# HISTORIC AND DESIGN REVIEW COMMISSION

January 15, 2025

**HDRC CASE NO:** 2024-426  
**ADDRESS:** 1602 BROADWAY  
1702 BROADWAY  
1611 N ALAMO  
1613 N ALAMO  
**LEGAL DESCRIPTION:** NCB 1765 (BESA), LOT 21  
NCB 1765 (BESA), LOT 20  
**ZONING:** IDZ-3, RIO-2, H  
**CITY COUNCIL DIST.:** 2  
**APPLICANT:** Mark Henderson/Ford Powell and Carson  
**OWNER:** BESA LAND PARTNERS LP  
**TYPE OF WORK:** Construction of a mixed-use development, relocation of a historic structure  
**APPLICATION RECEIVED:** December 20, 2024  
**60-DAY REVIEW:** February 18, 2025  
**CASE MANAGER:** Edward Hall  
**REQUEST:**

The applicant is requesting conceptual approval for approval to:

1611 North Alamo

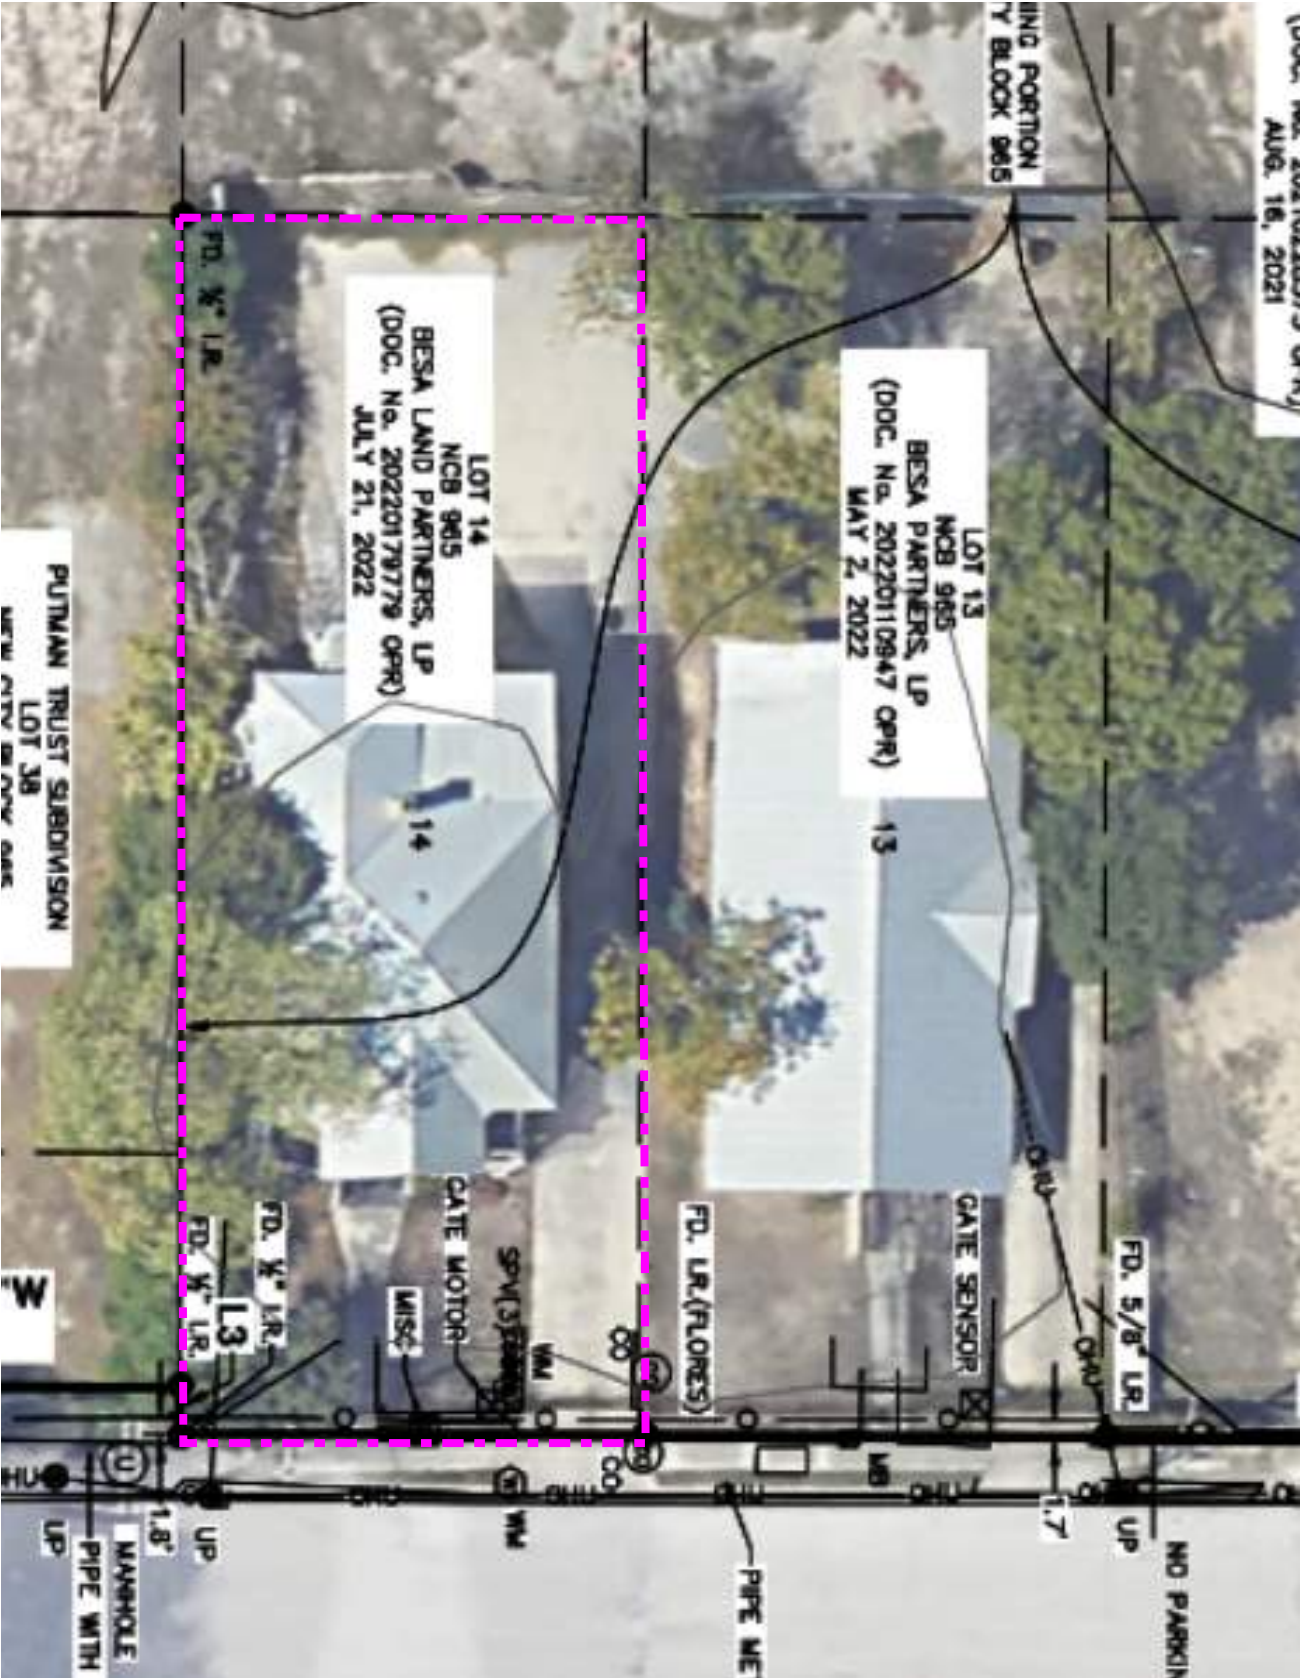
- d. **RELOCATION** – The applicant has proposed to relocate the two-story, historic structure, to a lot within the Government Hill Historic District. The applicant has not specified the lot at this time. The UDC Section 35-613 provides guidance for the relocation of a historic structure. Per this section, the Historic and Design Review Commission shall be guided by the following considerations: 1) the historic character and aesthetic interest the building contributes its present setting; 2) whether there are definite plans for the area to be vacated and what the effect of those plans on the character of the surrounding area will be; 3) whether the building can be moved without significant damage to its physical integrity; 4) whether the proposed relocation area is compatible with the historical and architectural character of the building; and 5) balancing the contribution of the property to the character of the historic district with the special merit of the application. Generally, staff finds the relocation of the structure to a lot within the Government Hill Historic District to be appropriate. Staff finds that the relocation details should be provided prior to returning to the Commission for final approval of the proposed new construction. These details should include a detailed construction document set, the cataloging of decorative architectural elements and building components and a detailed plan for the physical relocation and any associated deconstruction or disassembly of the structure to facilitate the proposed relocation. The new location must also be designated by the owner as a local historic landmark.

- i. That the relocation location for the historic structure at 1611 N Alamo be determined prior to returning to the Commission for final approval of the proposed new construction, as noted in finding d. These details should include a detailed construction document set, the cataloging of decorative architectural elements and building components and a detailed plan for the physical relocation and any associated deconstruction or disassembly of the structure to facilitate the proposed relocation. The new location must also be designated by the owner as a local historic landmark.

# Phase I Plan • L1 Plan

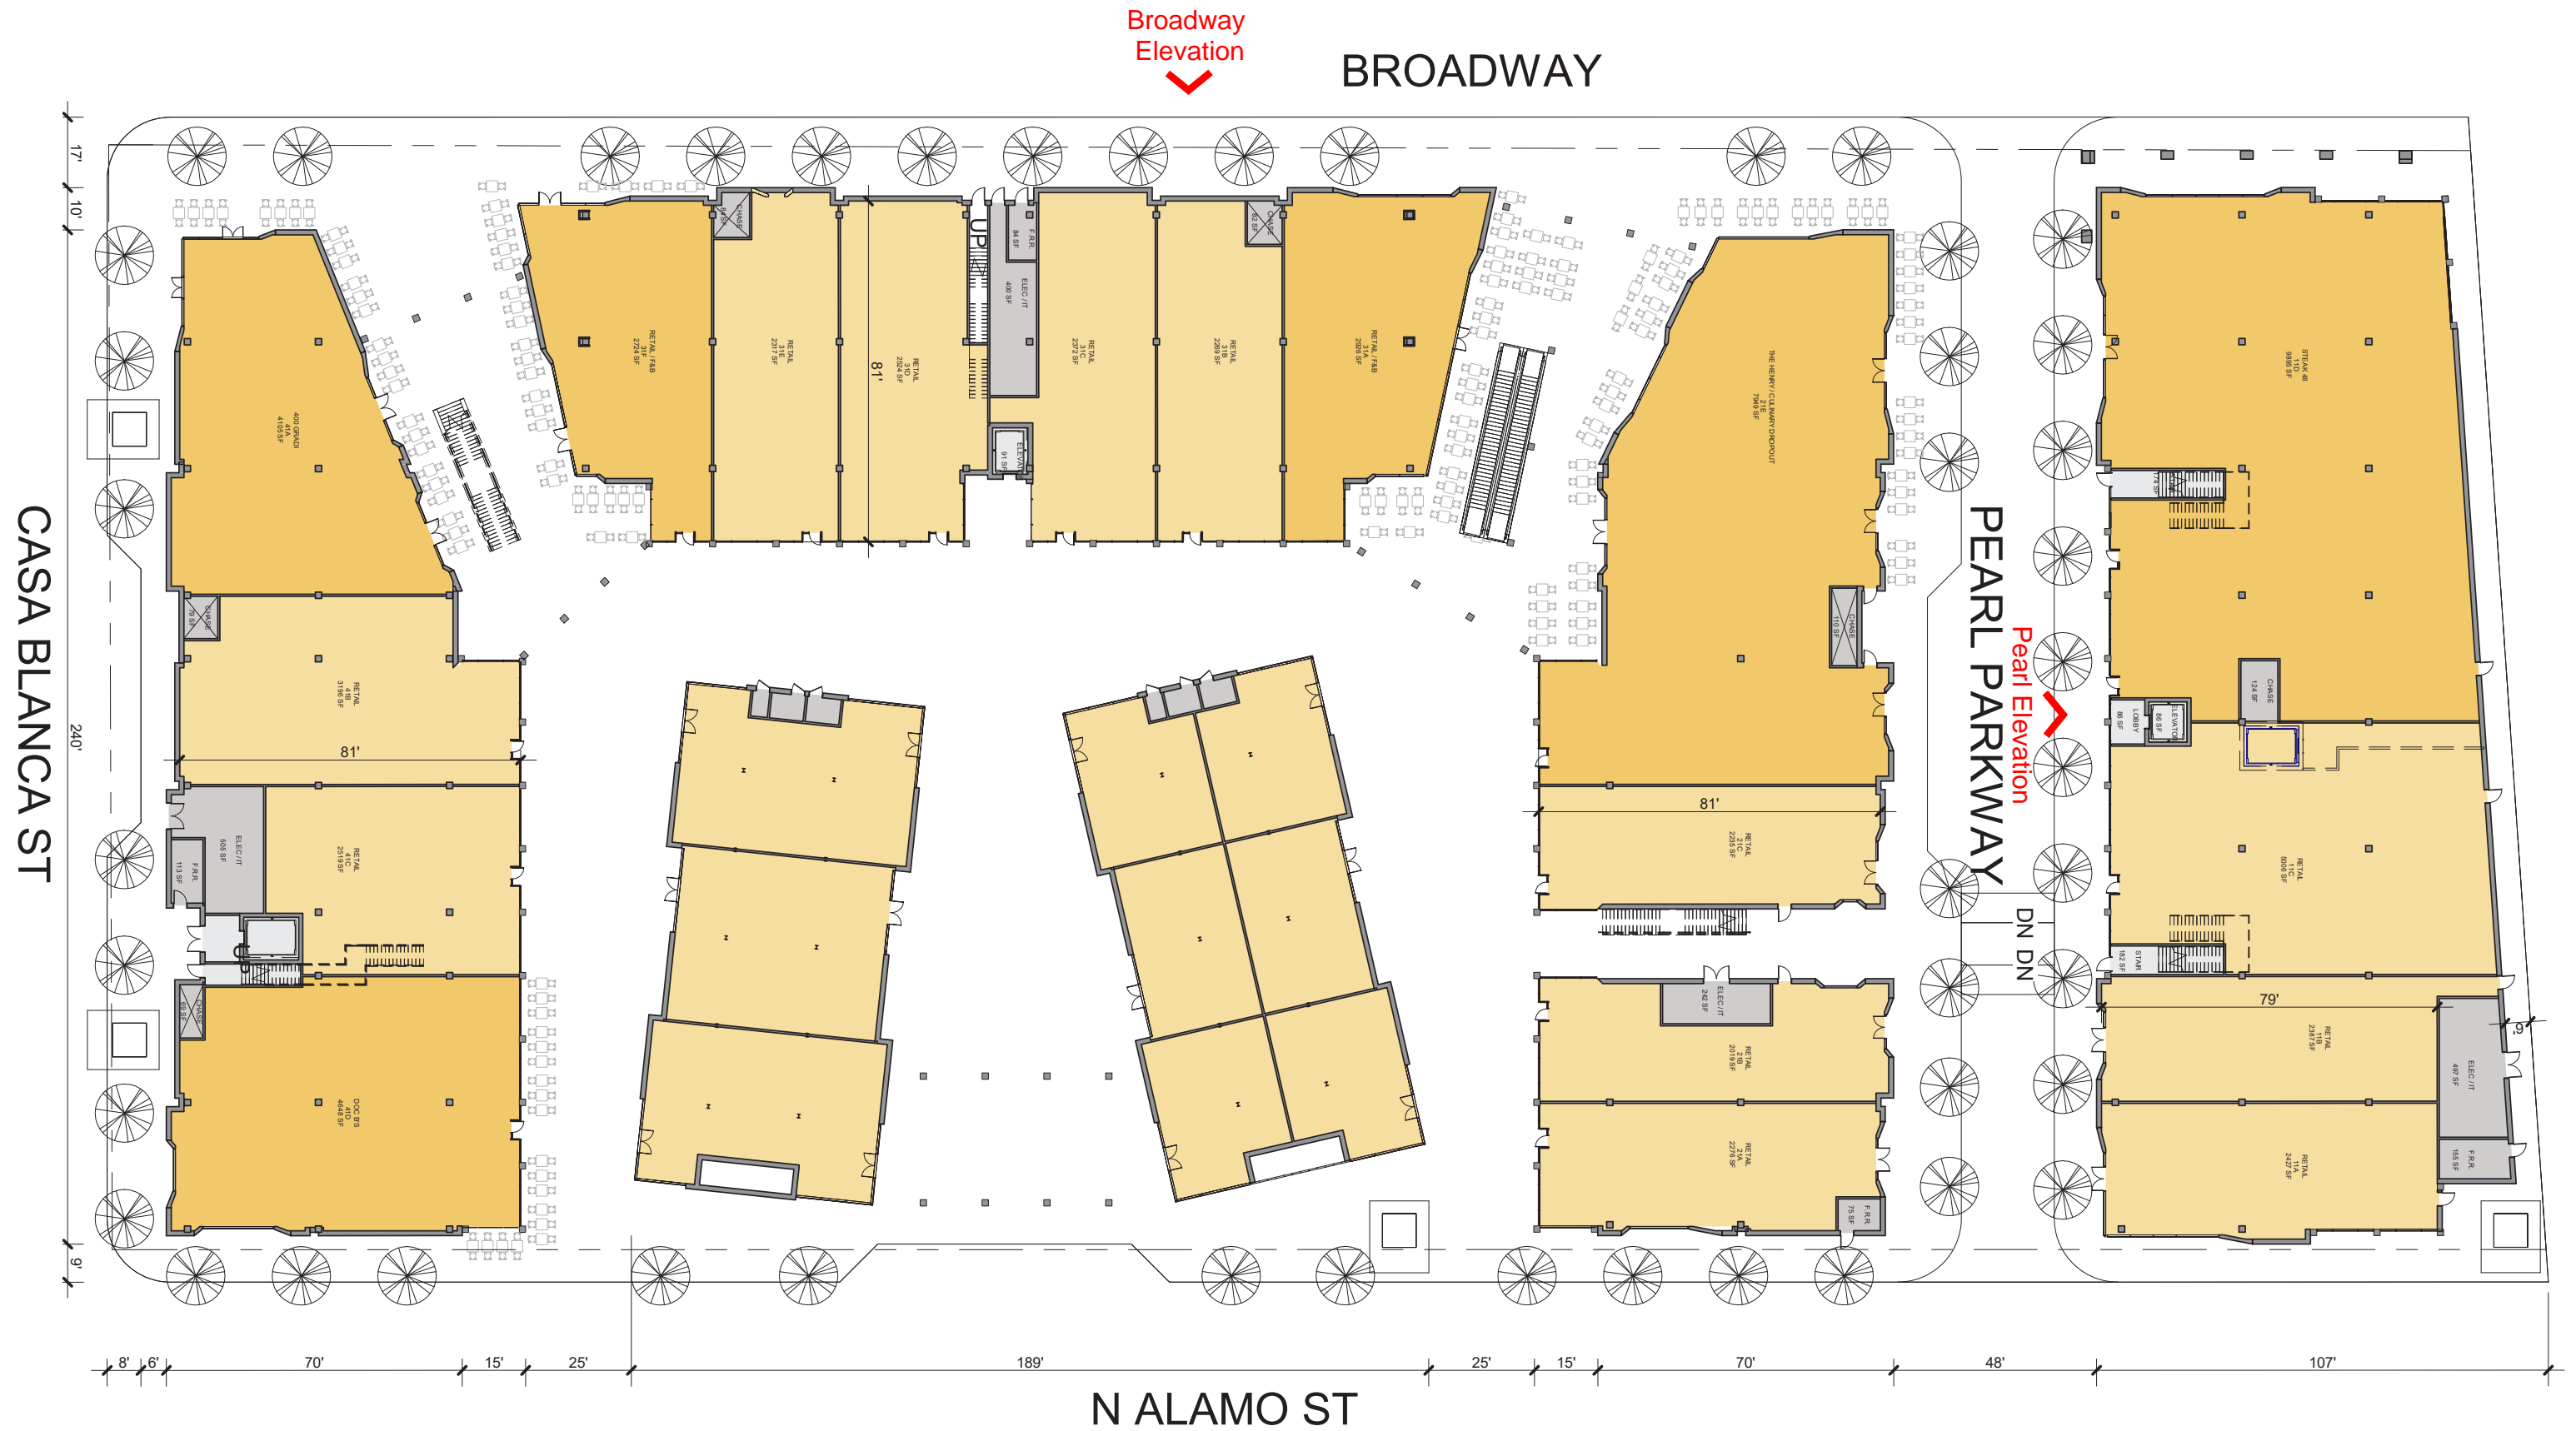
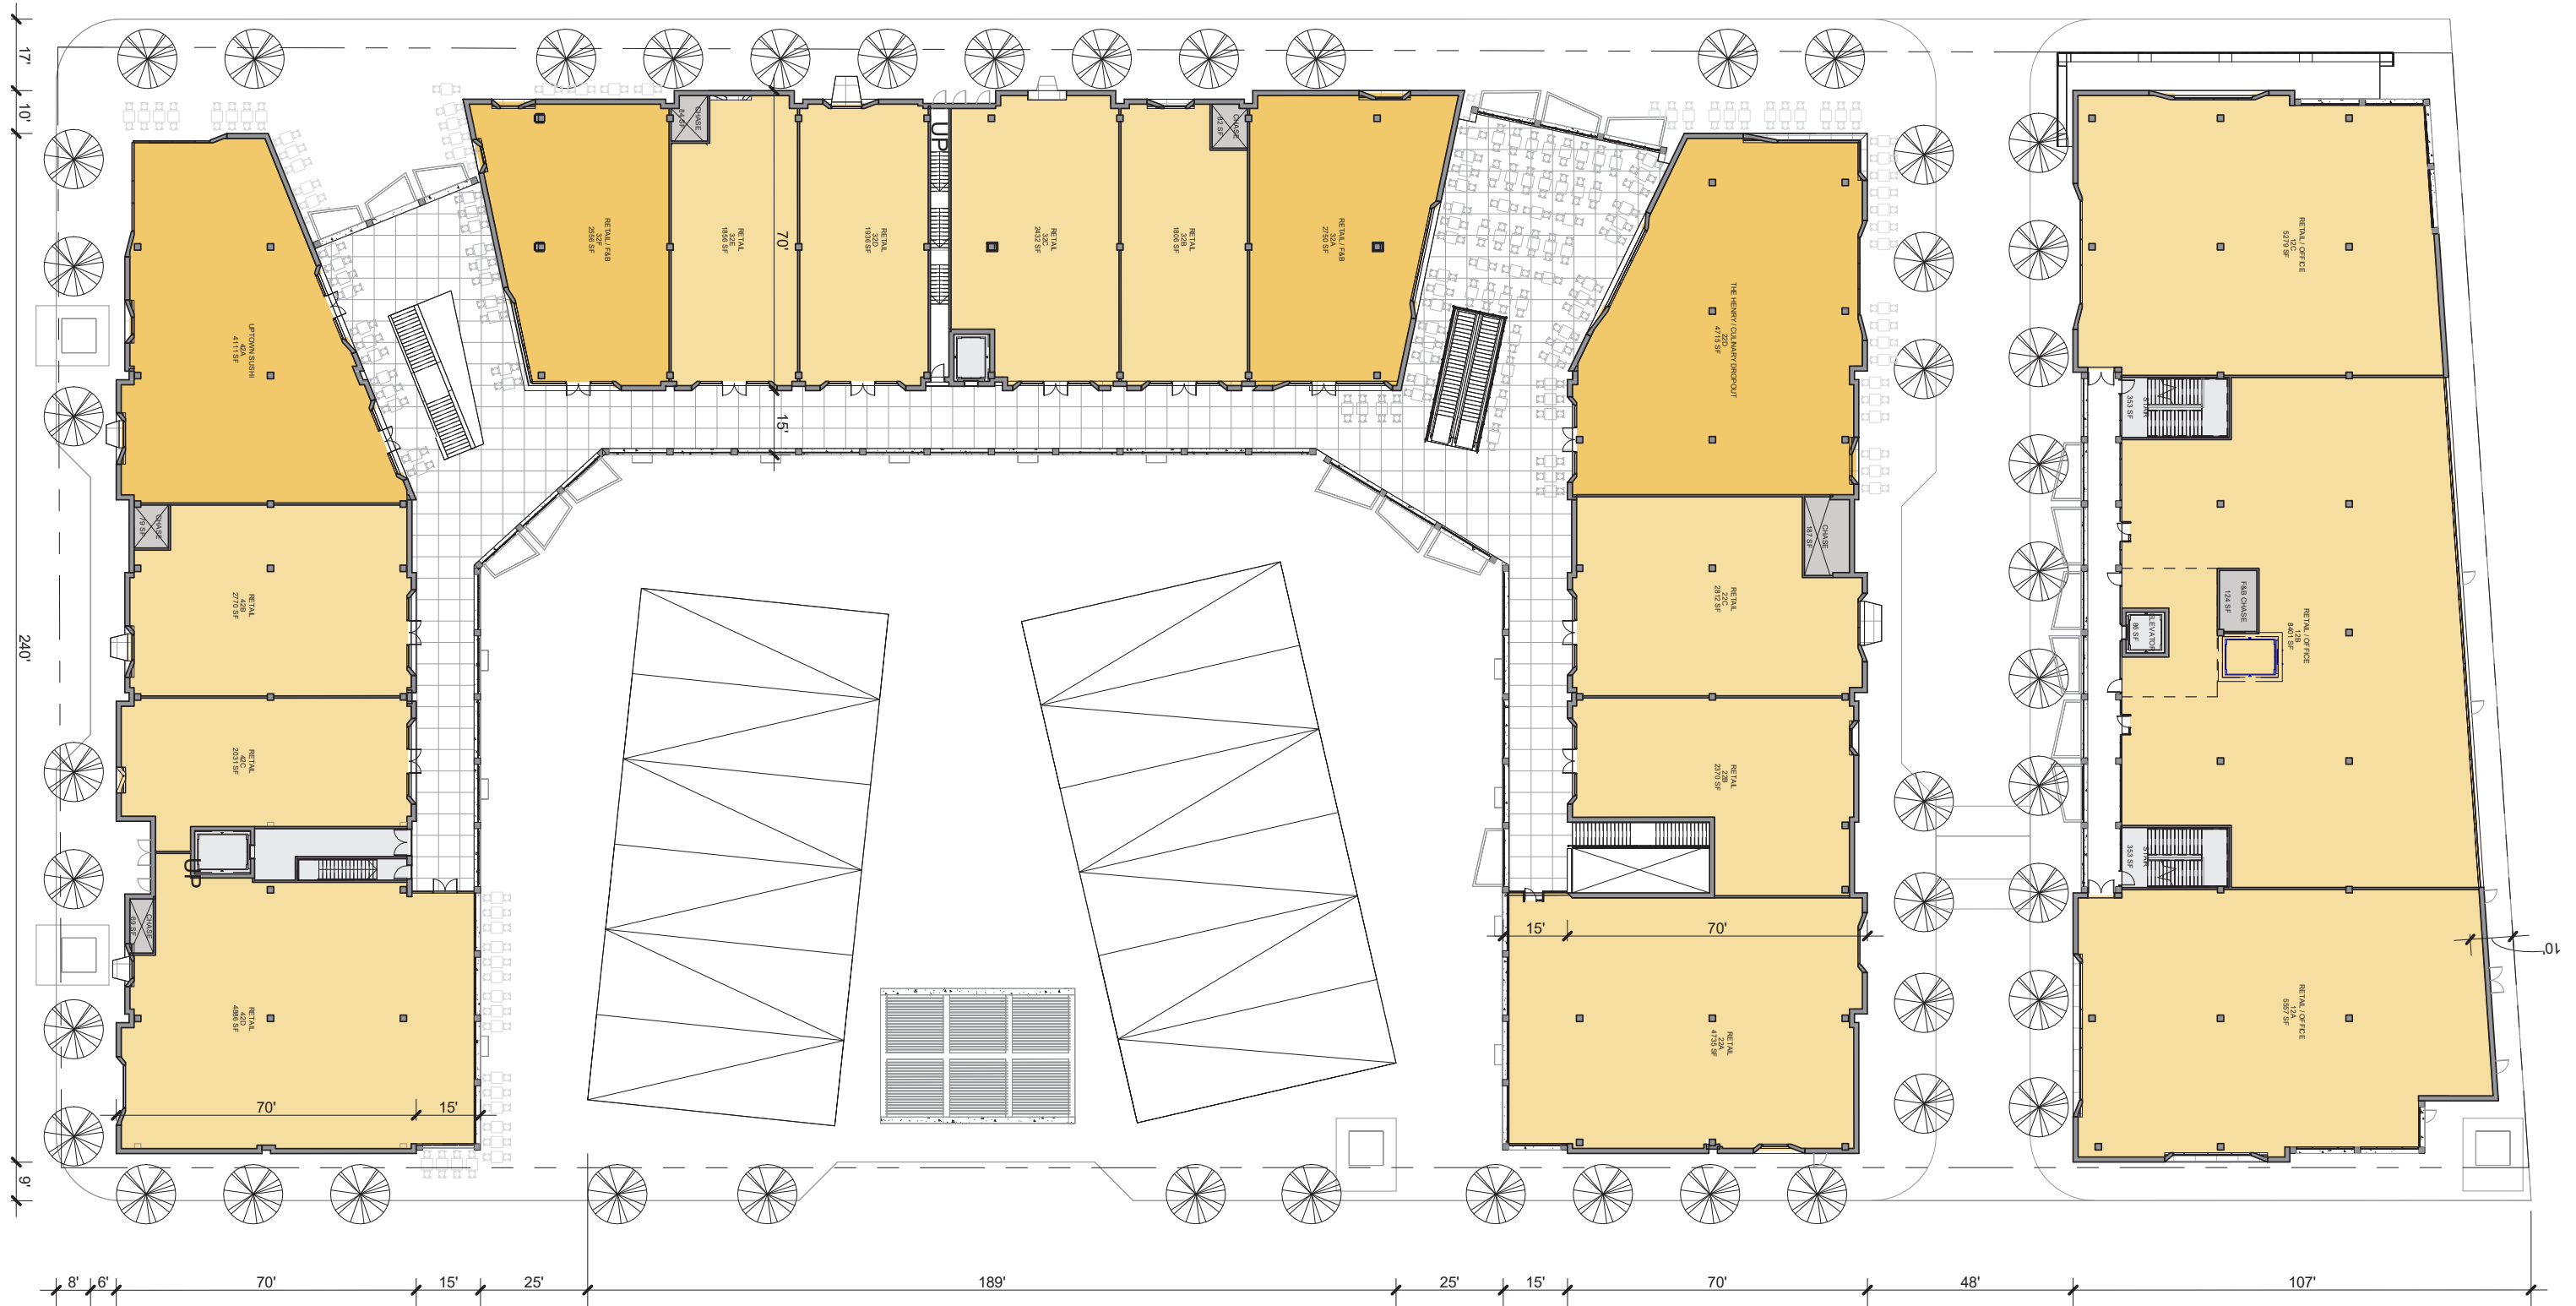
- e. **PEDESTRIAN CIRCULATION** – Per the UDC Section 35-672(a) regarding pedestrian circulation, an applicant shall provide pedestrian access among properties to integrate neighborhoods. The applicant has proposed to connect the site with adjacent rights of way in various locations. Staff finds the proposed pedestrian circulation to be appropriate and consistent with the UDC.

- f. **CURB CUTS** – This site currently features multiple curb cuts on Broadway, Casa Blanca and N Alamo. The applicant has proposed to remove these curb cuts and install one valet/parallel parking space on both Casa Blanca and N Alamo. The applicant has also proposed an additional curb cut on Broadway and N Alamo to facilitate the extension of Pearl Parkway. Staff finds each of the proposed curb cuts to be appropriate.

- g. **SITE DESIGN** – According to the UDC Section 35-673, buildings should be sited to help define active spaces for area users, provide pedestrian connections between sites, help animate the street scene and define street edges. Primary entrances should be oriented toward the street and shall be distinguishable by an architectural feature. The applicant has cited each building to define active spaces. Additionally, the applicant has cited the primary buildings to be oriented towards primary streets. Staff finds the proposed site design to be appropriate and consistent with the UDC.
